Project	<b>IEEE 802.16 Broadband Wireless Access Working Group</b> < <a href="http://ieee802.org/16">http://ieee802.org/16</a> >
Title	<b>Optional DL PUSC design</b>
Date Submitted	<b>2004-08-17</b>
Source(s)	Jeong-Heon Kim, Panyuh Joo, Seung Joo Maeng, Jaeho Jeon, Soon Young Yoon Samsung Electronics Co., Ltd.
Re:	Contribution supporting Sponsor ballot
Abstract	In this contribution, optional DL PUSC which shows enhanced performance is proposed
Purpose	Adoption of suggested changes into P802.16e/D4
Notice	This document has been prepared to assist IEEE 802.16. It is offered as a basis for discussion and is not binding on the contributing individual(s) or organization(s). The material in this document is subject to change in form and content after further study. The contributor(s) reserve(s) the right to add, amend or withdraw material contained herein.
Release	The contributor grants a free, irrevocable license to the IEEE to incorporate material contained in this contribution, and any modifications thereof, in the creation of an IEEE Standards publication; to copyright in the IEEE's name any IEEE Standards publication even though it may include portions of this contribution; and at t

**Figure 1 - Subcarrier allocation for optional downlink PUSC**

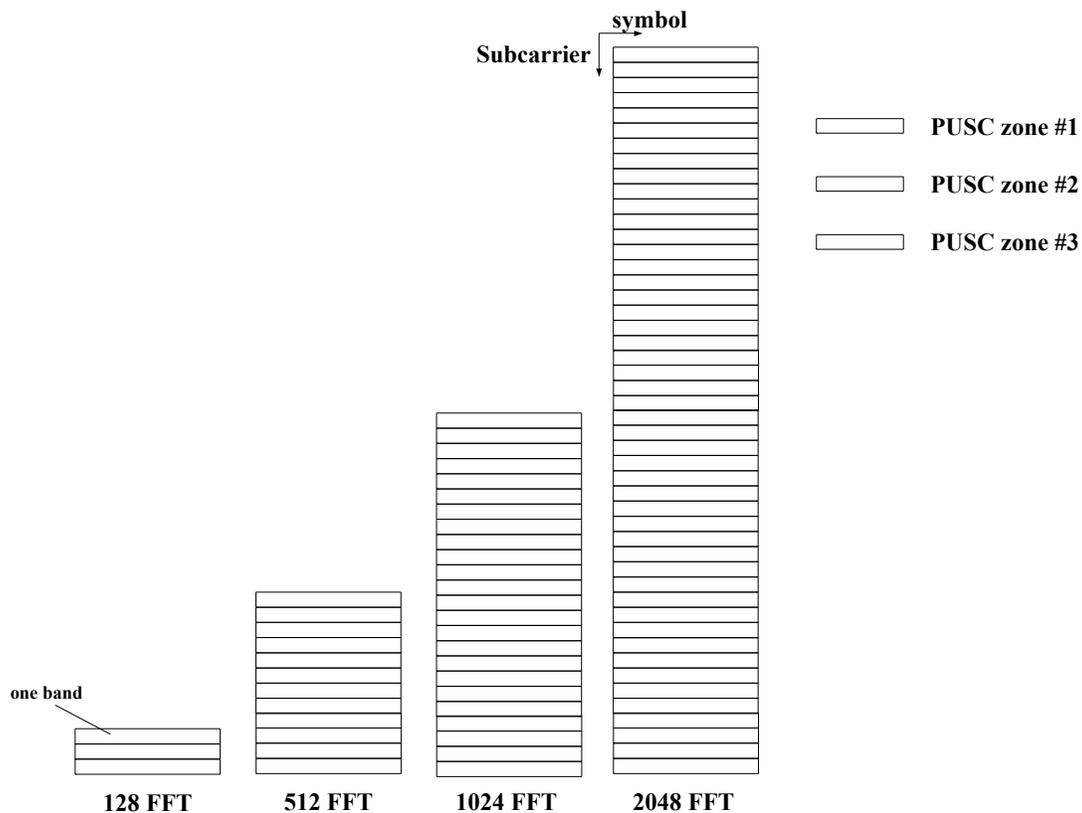
Subcarrier allocation for optional PUSC is depicted in Figure 1. A bunch of 9 contiguous subcarriers containing 1 pilot carrier and 8 data carriers is called a bin and 4 consecutive bins are called a band. Those bands are divided into three segments each of which is assigned to a PUSC zone.

For optional PUSC operation, total bands are partitioned into 3 segments and subchannel subcarrier allocation is done in each segment. The partition into 3 segments is shown in Figure 1. To allocate the diversity subchannels, data tones in 3 consecutive symbols in a segment are partitioned into 48 groups of contiguous data subcarriers. Each subchannel consists of one subcarrier from each of these groups. The exact partitioning into subchannels is according to the permutation formula in section 8.4.6.1.2.3.1. As shown in Table 309a,  $N_s$  is determined by FFT size. Also, the basic permutation sequences  $P_1$  and  $P_2$  are shown in Table 309a. The enumeration of the subcarriers in a segment within three symbols starts from the lowest numbered data subcarrier of the first symbol in a segment and goes to the next carriers. If it reaches the last carrier in the symbol in the segment, it goes to the lowest data carrier of the next symbol and so on.
